ADDENDUM NUMBER: #5

DATE: January 4, 2024

PROJECT NAME: ᲑᲗᲗᲗ ᲑᲗᲗᲗ Our House Cultural Facility and Traditional Foods Processing Center

PROJECT NO. 1702-TLM

**A2.3**

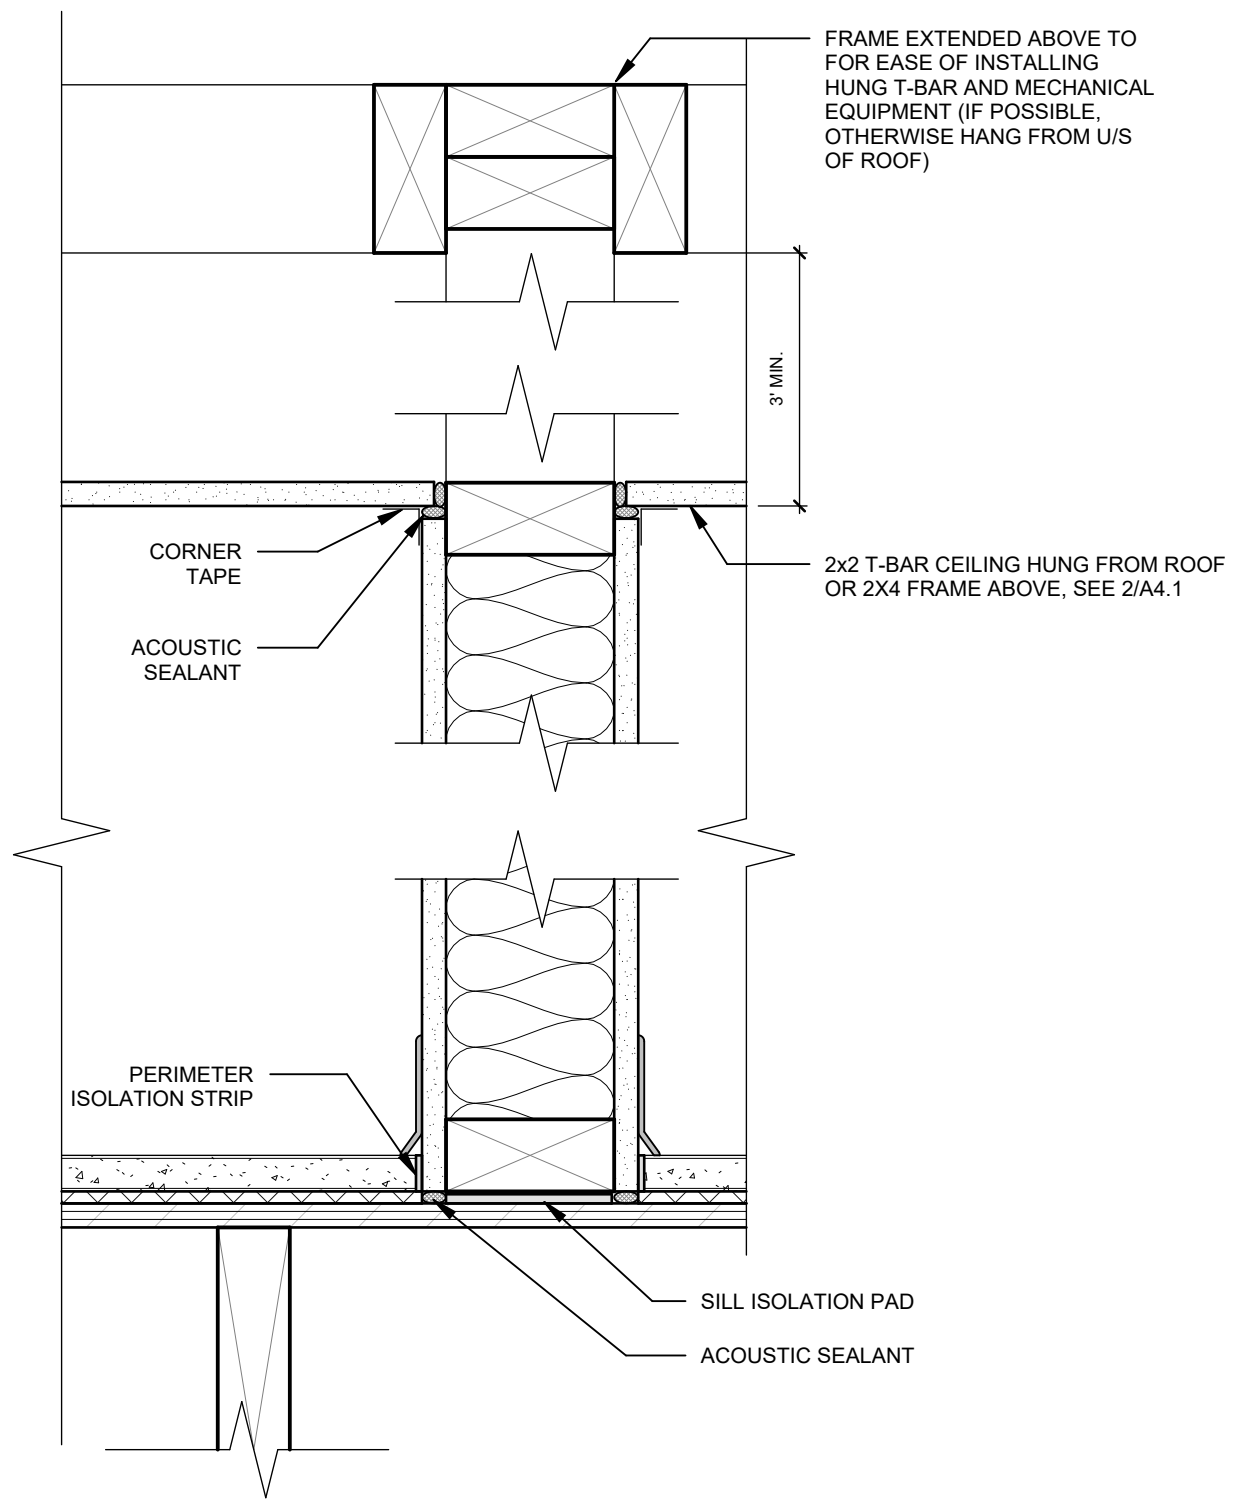
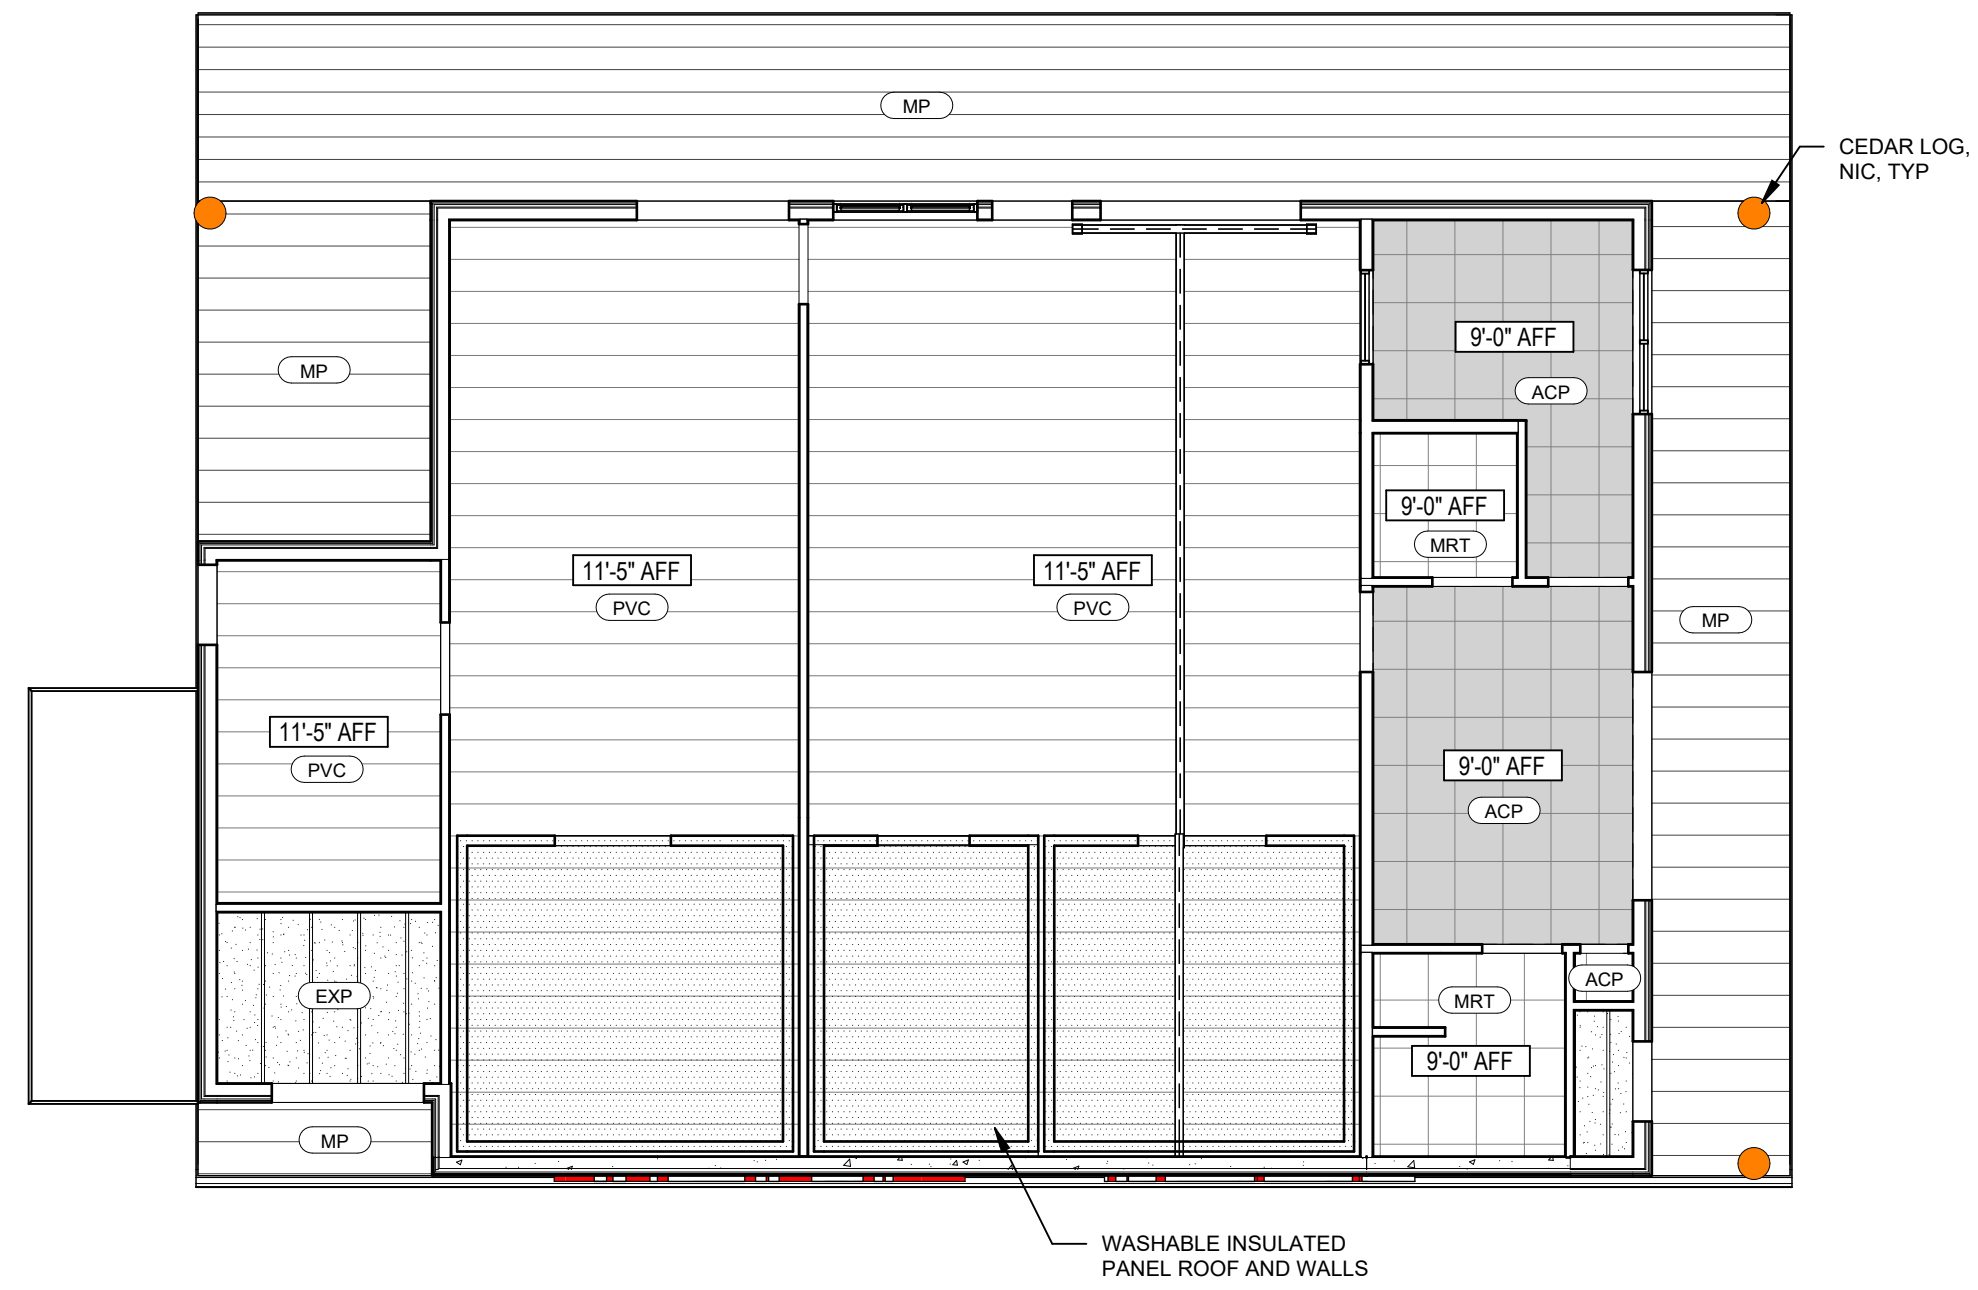
1. Acoustic tile codes added to A2.3: REFLECTED CEILING PLAN & FINISHES SCHEDULE sheet.
  - a. Acoustic tile codes added to reference 09 51 00

ADDENDUM

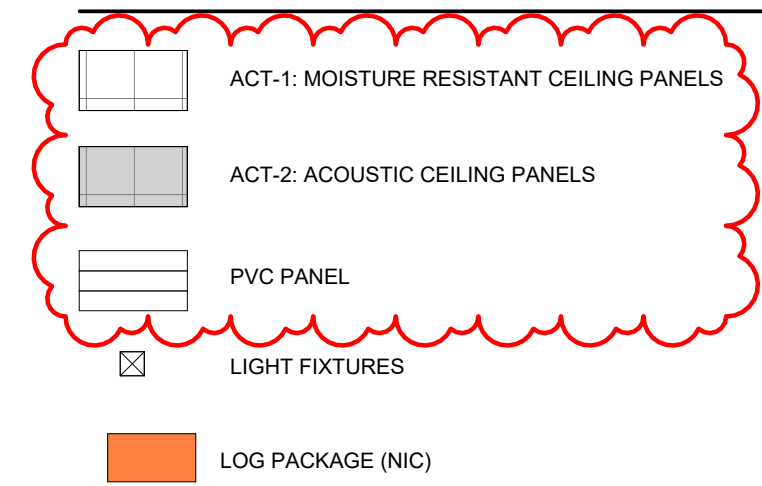
1. Acoustic tile codes added to ADDENDUM 05 sheet.
  - a. Acoustic tile codes added to reference 09 51 00
